UNIVERSITY OF READING PHYSICS DEPARTMENT

12 Aug 1976

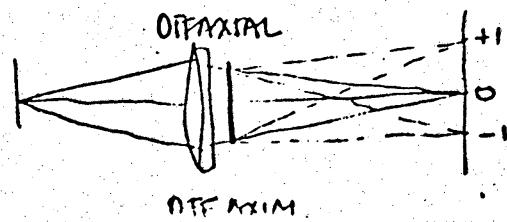
Suppose we take an input ϕ of 30mm diameter, 5 20μm-spaced samples across an Airy disc central peak, a 100 c/mm spatial carrier, and a 100mm square diffracted map size. Then we get, for a SINGLE-COMPONENT lens,

$$F = 1\text{ m} \quad F\# = 66.7 \text{ (for imaging beam)} \\ F\# = 33.3 \text{ overall}$$

and a 126 mm separation of diffracted orders.

Comment 1 : The two modes of operation that you refer to as AXIAL and OFF-AXIAL are:
